Revised Site & Civil Plan (3.27.25) 38229 Manzella Dr (Markups).pdf Markup Summary

NEW OFFICE / STORAGE
 38229 MANZELLA DRIVE, SLIDELL, LOUISIANA
 JOB No: 38229
 DATE: 03-11-2025
 DRAWN BY: BAW
 CHECKED BY: C&D

SHEET TITLE: PROPOSED DRAINAGE AND PAVING PLAN
 DRAWING NUMBER: C100
 SHEET No: 1 of 6

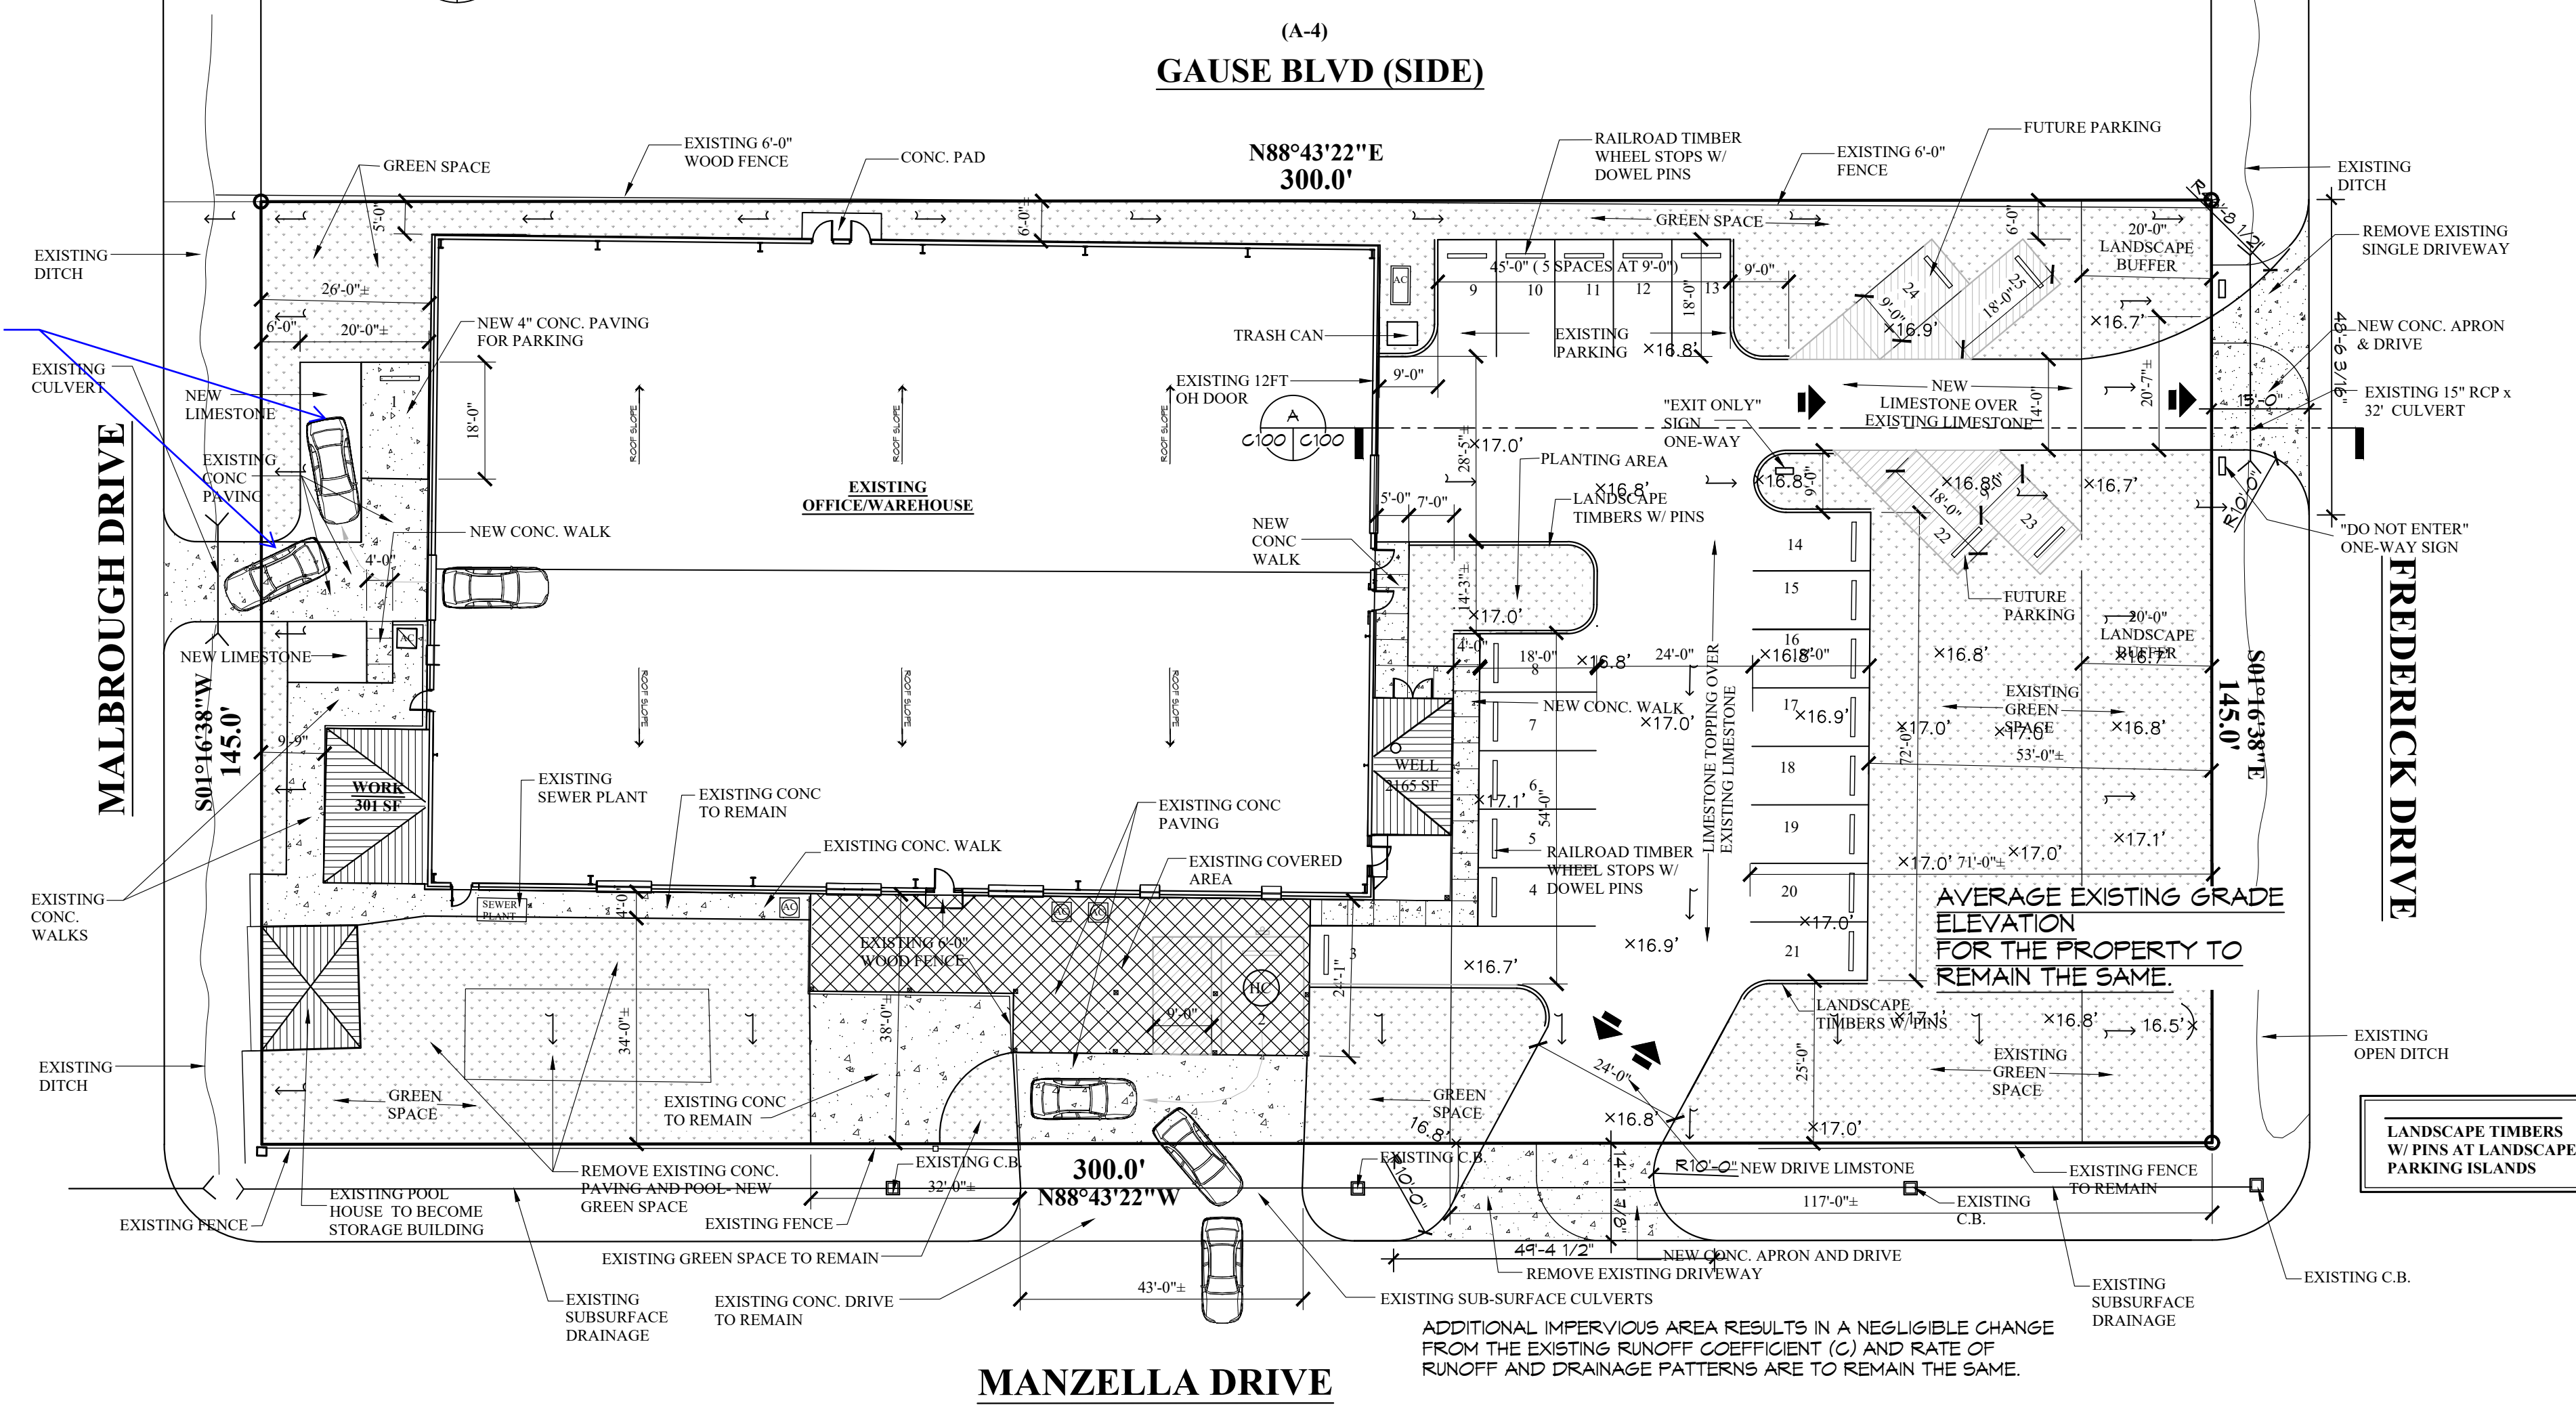
Per previous comment:

Revise Runoff Coefficient (C) = 0.95 for watertight surfaces per STP Ordinance Sec. 900-6.3(F); Exhibit 900-6-6.

Revise Runoff Coefficient (C) = 0.7 for gravel per STP Ordinance Sec. 900-6.3(F); Exhibit 900-6-6.

Revise Runoff Coefficient (C) = 0.3 for greenspace per STP Ordinance Sec. 900-6.3(F); Exhibit 900-6-6.

(TYPICAL for both pre & post development.)

Per previous comment:

Revise autoturn simulation to show proposed vehicular maneuvering to & from proposed parking space

(including wheel movement/radii). (TYP)

(Needs to show vehicle swept path.) (TYP)

Per previous comment:

Provide "Weighted" Runoff Coefficient (C) for both pre & post development.

Calculations do not appear to have been updated as required.

Per previous comment:
 Revise autoturn simulation to show proposed vehicular maneuvering to & from proposed parking space
 (including wheel movement/radii). (TYP)
 (Needs to show vehicle swept path.) (TYP)

Per previous comment:
 Provide "Weighted" Runoff Coefficient (C) for both pre & post development.
 Calculations do not appear to have been updated as required.

SITE PLAN- NEW WORK

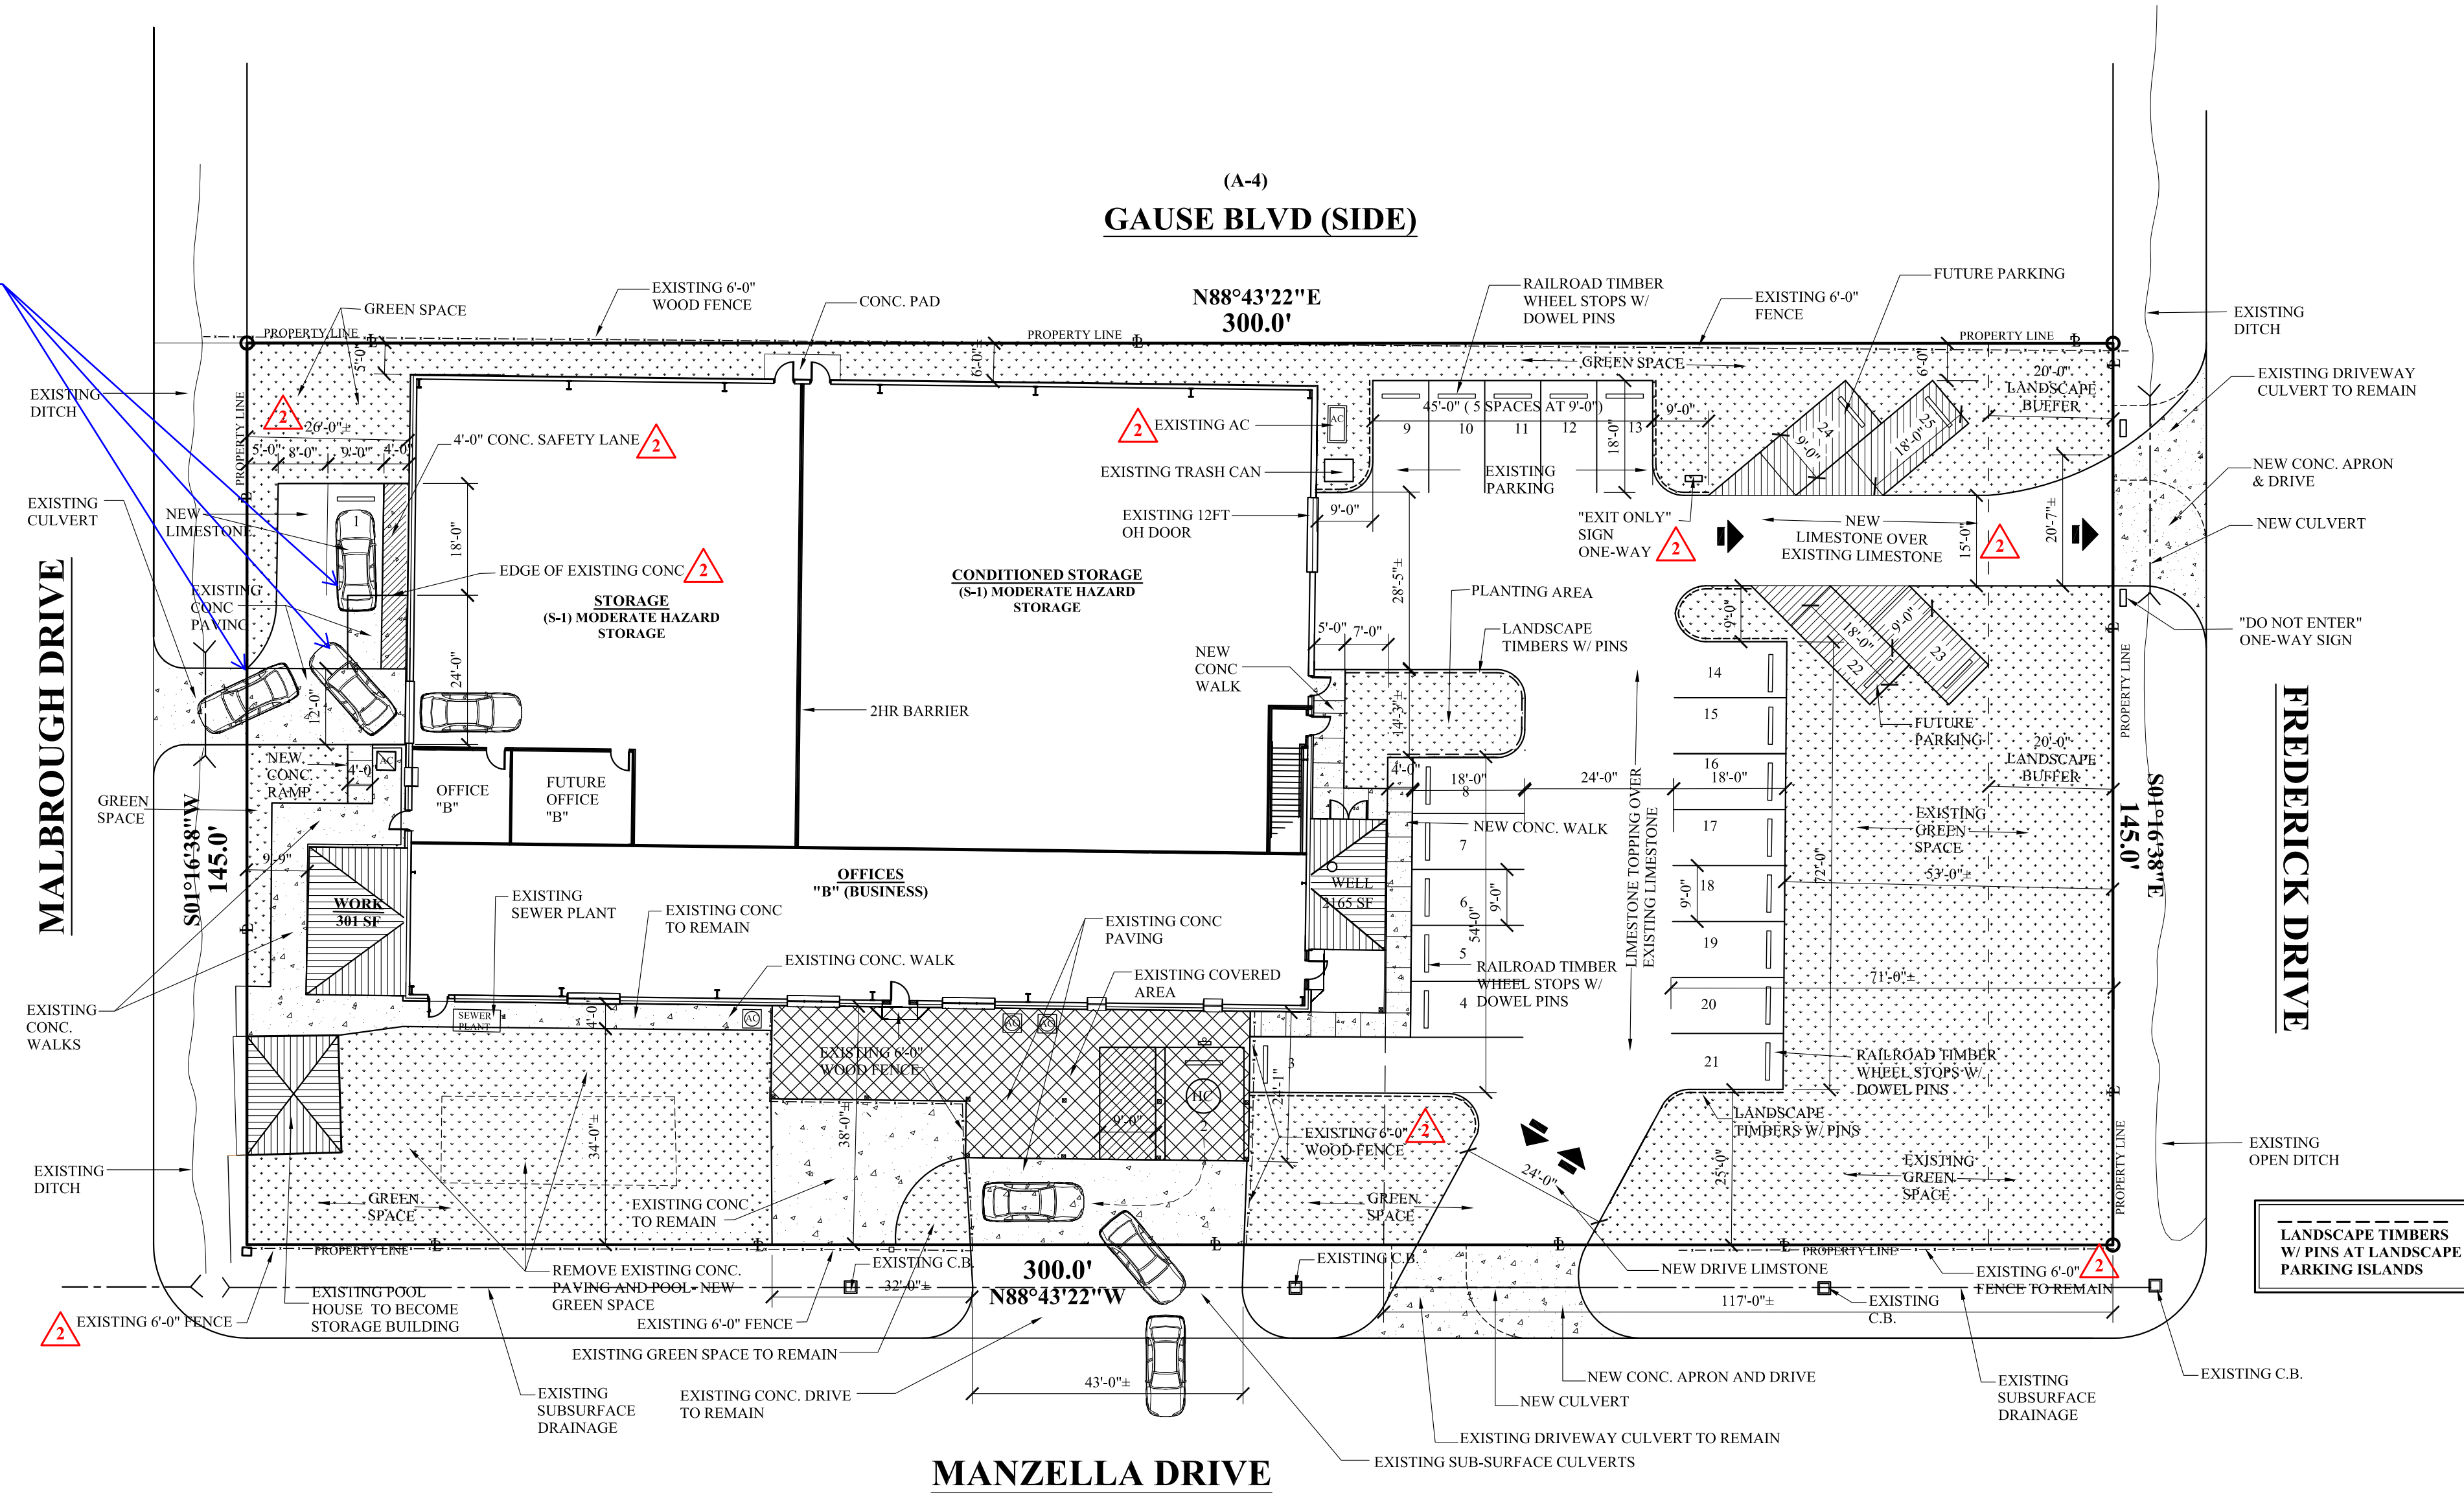
Per previous comment:

Revise autoturn simulation to show proposed vehicular maneuvering to & from proposed parking space

(Needs to show vehicle swept path.) (TYP)

This is different from what is shown on civil plan.

Per previous comment:
Revise autoturn simulation to show proposed vehicular maneuvering to & from proposed parking space
(Needs to show vehicle swept path.) (TYP)
This is different from what is shown on civil plan.
